**Report: TAB Report**  
**Function: Test, Adjust, & Balance**  
**Date: 07/18/2025**  
**Completed By: National TAB**

**PROJECT**  
**04-14-25 ULTA 1967 SELMA, NC**

## Issue List

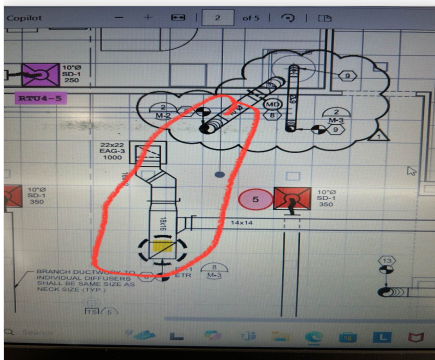
**Issue Name :** EF-1 backdraft damper  
**Description :** Screw, preventing backdraft damper to open fully.  
**Created By :** National TAB                      **Assigned To :** National TAB - Dan Hertenstein  
**Status :** Open  
**Priority :** Urgent                                      **Asset Tag :** EF1  
**Originated Date :** 01/08/2025 - Jearod Ferrette - National TAB

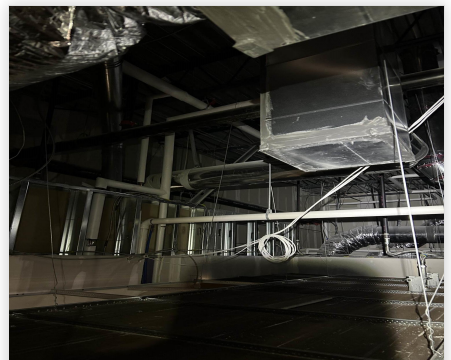
**Issue Name :** EF-1 curbed wrong  
**Description :** EF-1 fan curbed to the wrong ductwork. The fan is installed to the water heater exhaust. Also, the motor is at max amps, going to a 10" round duct. Currently getting 522 cfm. EF-1 is design for 1750 cfm. The Greenheck GB-130 website states that max flow is 1249 cfm.  
**Created By :** National TAB                      **Assigned To :** National TAB - Dan Hertenstein  
**Status :** Open  
**Priority :** Urgent                                      **Asset Tag :** EF1  
**Originated Date :** 01/08/2025 - Jearod Ferrette - National TAB

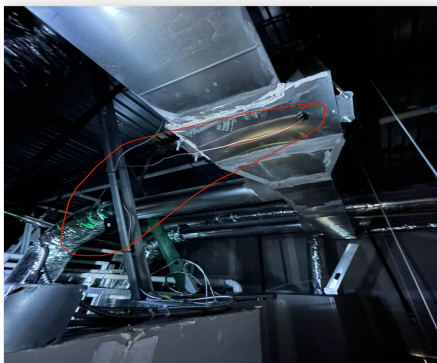
**Issue Name :** EF-2 Dampers not installed  
**Description :** EF-2 dampers are not installed. However the airflows are proportional so they likely will not be required.  
**Created By :** National TAB                      **Assigned To :** National TAB - Dan Hertenstein  
**Status :** Open  
**Priority :** Low                                      **Asset Tag :** EF2  
**Originated Date :** 10/17/2024 - Will Turnbough - National TAB

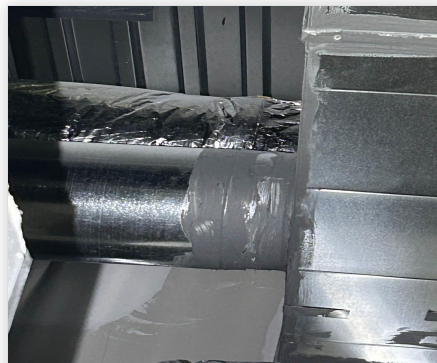
**Issue Name :** EF-2 Restroom fan unable to access  
**Description :** EF-2 speed controller is located above hard ceiling and is inaccessible. Unable to reach from other side with ladder due to piping obstructing access. The unit is running at 117% of design.  
**Created By :** National TAB                      **Assigned To :** National TAB - Dan Hertenstein  
**Status :** Open  
**Priority :** High                                      **Asset Tag :**  
**Originated Date :** 10/14/2024 - Jearod Ferrette - National TAB

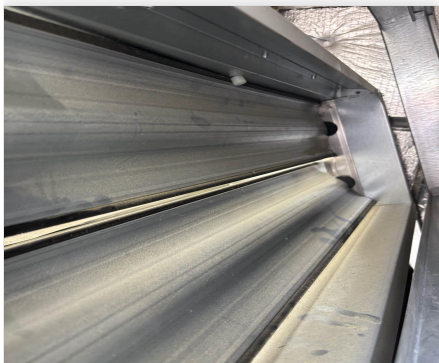
**Issue Name :** Missing Turning vane elbow  
**Description :** EF-1 doesn't has the provided turning elbow installed.  
**Created By :** National TAB                      **Assigned To :** National TAB - Dan Hertenstein  
**Status :** Open  
**Priority :** Urgent                                      **Asset Tag :** EF1  
**Originated Date :** 01/08/2025 - Jearod Ferrette - National TAB

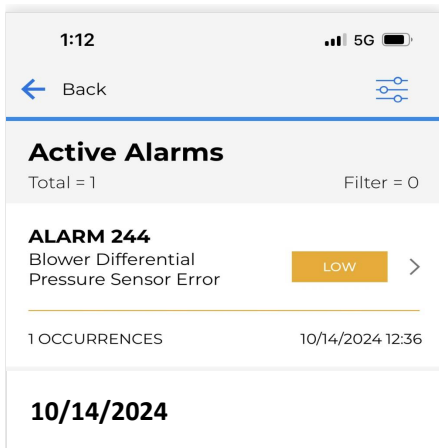
**Issue Name :** RTU -4 airflow is 149% of design  
**Description :** RTU-4 airflow is 149% of design. Unable to slow unit down with the CORE controller. There is an alarm code 244 (Blower differential pressure sensor error) that appears to be preventing speed adjustment.  
**Created By :** National TAB                      **Assigned To :** National TAB - Dan Hertenstein  
**Status :** Open  
**Priority :** High                                      **Asset Tag :** RTU4  
**Originated Date :** 10/14/2024 - Jearod Ferrette - National TAB

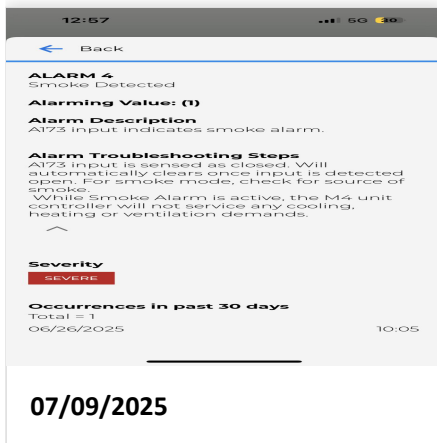
**Issue Name :** RTU-1 airflow is 84% of design  
**Description :** RTU-1 airflow is 84% of design. The pulley cannot be increased further without the belt sitting too high up on the pulley. A pulley change is recommended.  
**Created By :** National TAB                      **Assigned To :** National TAB - Dan Hertenstein  
**Status :** Open  
**Priority :** High                                      **Asset Tag :** RTU1  
**Originated Date :** 10/15/2024 - Jearod Ferrette - National TAB

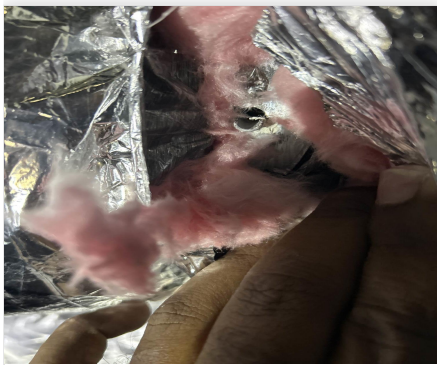
**Issue Name :** RTU-2 diffuser 24 damper is closed  
**Description :** Damper for diffuser 24 is closed and not accessible. There is a shelf that is directly underneath the damper. Damper is also installed on the top of the duct. It needs to be opened and a face accessible opposed blade damper is recommended in case further balancing is required.  
**Created By :** National TAB                      **Assigned To :** National TAB - Dan Hertenstein  
**Status :** Open  
**Priority :** Low                                      **Asset Tag :** RTU2  
**Originated Date :** 10/15/2024 - Jearod Ferrette - National TAB

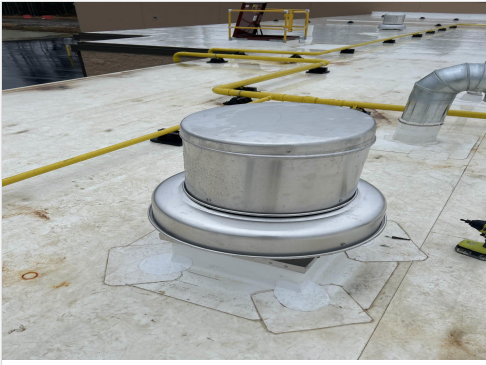
Notes:  
LOW FLOW SEE ISSUE  
(Rotation incorrect) (no disconnect)
